# Six 56 Warrington

Addendum to Environmental Statement

Part 2 – Noise and Vibration Technical Paper 7

Revision 412 22 March 2019 14 October 2020

Figure 7.2a: Extent of bund and acoustic barrier mitigation measures – 2D Plan

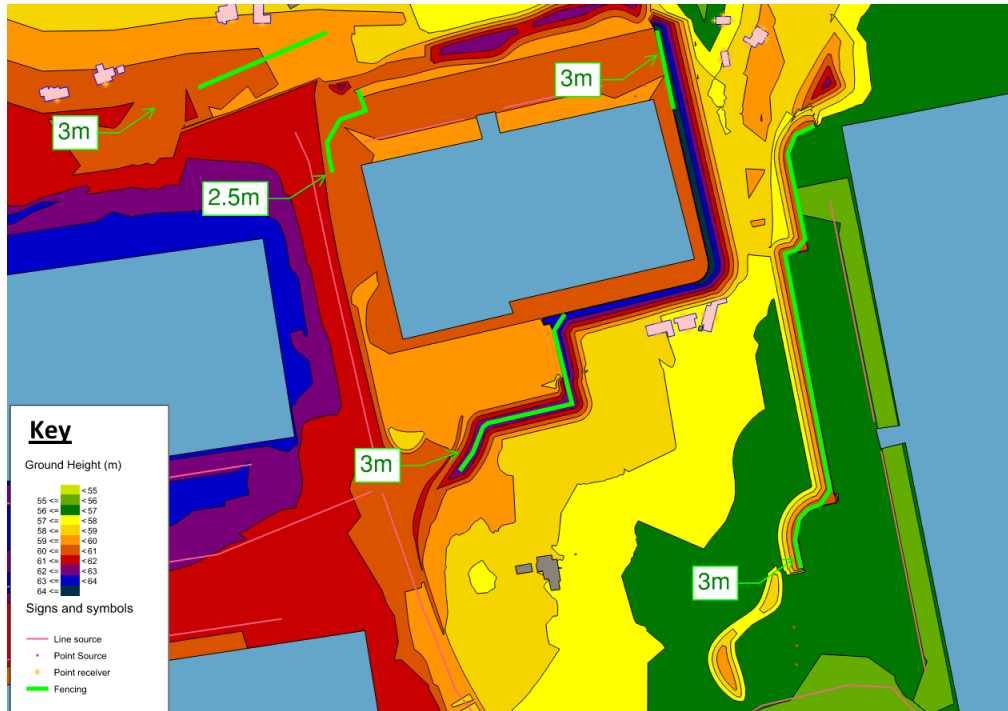
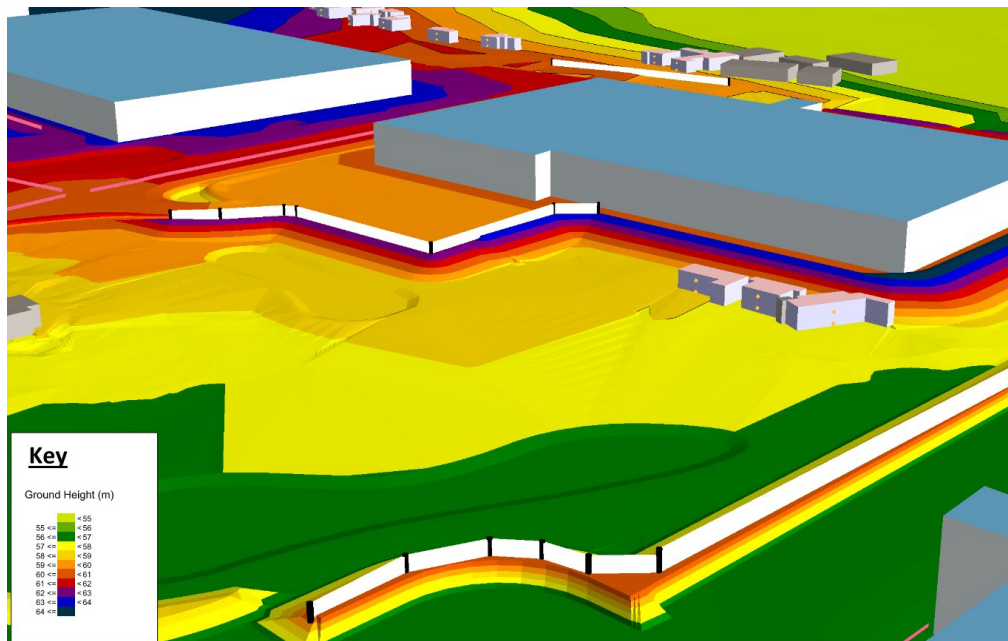
- 7.53. Detailed elevation levels associated with this bund have been incorporated within the updated SoundPLAN digital ground model.
- 7.54. The 'Proposed Finish Level Including Mounds' drawing (Cundall drawing no. ~~CLXX(52)4003~~ Issue—CLXX(52)4003 Issue P4) shows the proposed bund as incorporated within the noise model. ~~The proposed landscaped bund is primarily to the south and west perimeter of the site, and to the north-east. It should be noted that the effective height of the bund varies from approximately 3m to 7m, dependent upon location. The proposed landscaped bunding is primarily to the east and south of Plot 1 and the west of Plot 2. The bunds to the east and south of Plot 1 incline to a 1 in 3 gradient to a maximum height of approximately 5m, with a 1.2m level off at the bund peak to enable the construction of fencing. The bunds to the east and south of Plot 2 also incline to a 1 in 3 gradient to a maximum height of approximately 4.5m, and also include a 1.2m level off at the bund peak to enable the construction of fencing.~~

- 3m Fence on the bund peak to the south of Plot 1 - west of Bradley Hall Cottages
  - 3m Fence the bund peak to the west of Plot 2 - east of Bradley Hall Cottages

- 7.56. The figures below show a clipped excerpt from Appendix 7.3 as well as a 3D view of proposed timber fencing.

Figure 7.4 – Example barrier mitigation proposals

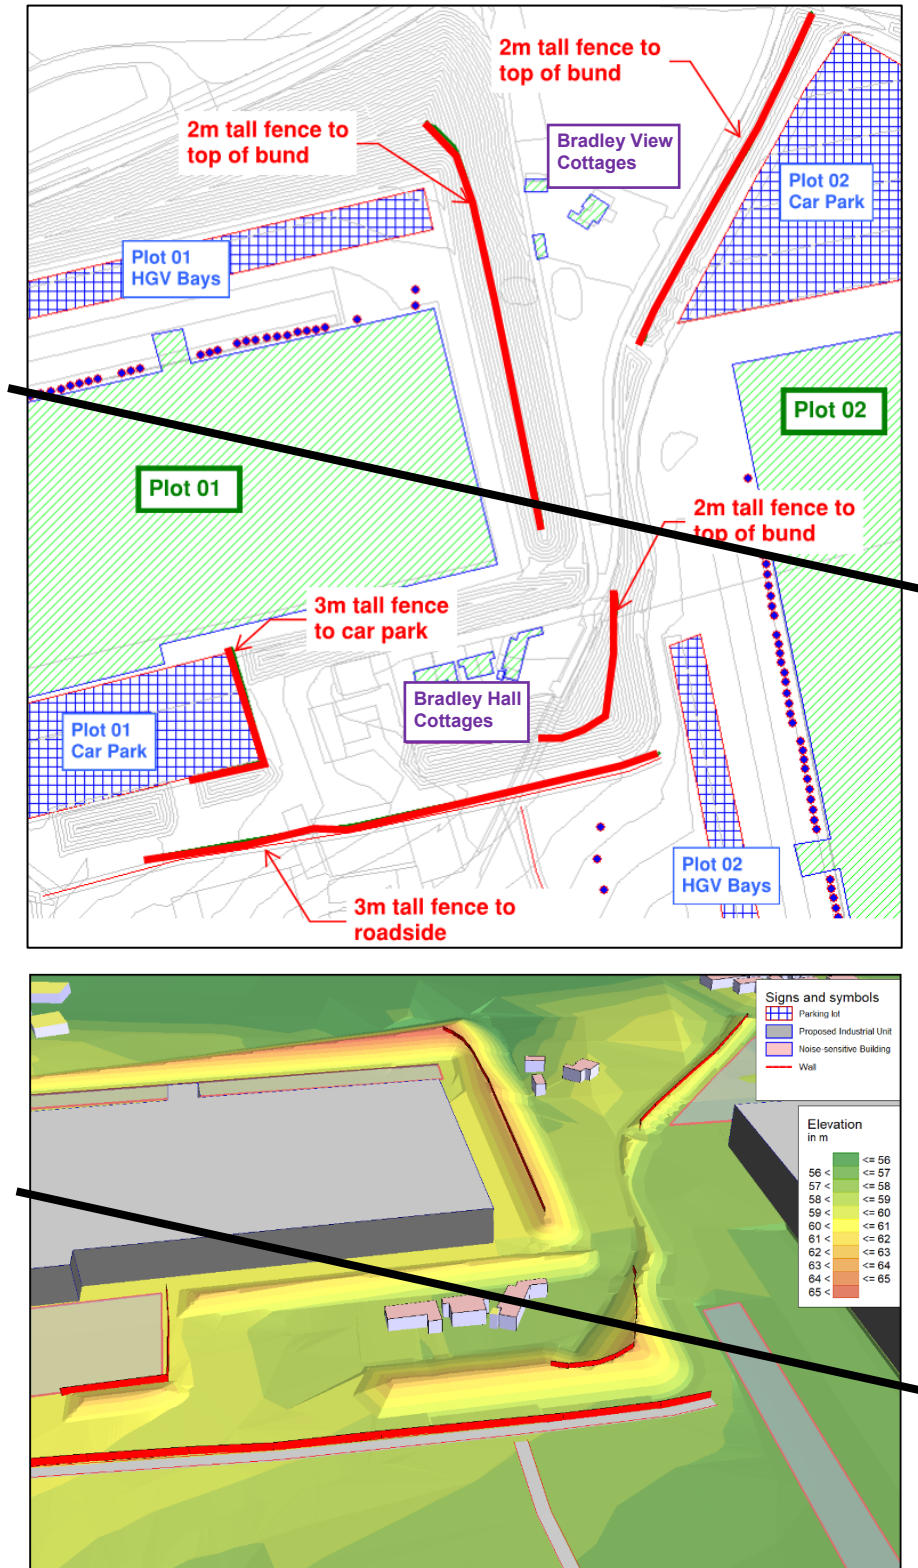
- ~~8.12. Through interrogation of the 3D noise model results for Operational Phase impacts at Bradley Hall Cottages and Bradley view (i.e. the two worst affected receptors), it has been determined that the dominant source of noise contribution is associated with LGV and HGV traffic movements along new access road and within parking areas.~~
- ~~8.13. Whilst it is considered unlikely that significant adverse effects can be avoided at these receptors, providing additional acoustic barrier screening to carefully considered roadside and bund locations should result in up to a 5 dB reduction in specific noise levels at these receptors.~~
- ~~8.14. The suggested extents and height of bunding and additional acoustic screening proposals are indicated in the following figures. All barrier should have a minimum area density of 10 kg/m<sup>2</sup> with no holes or gaps.~~
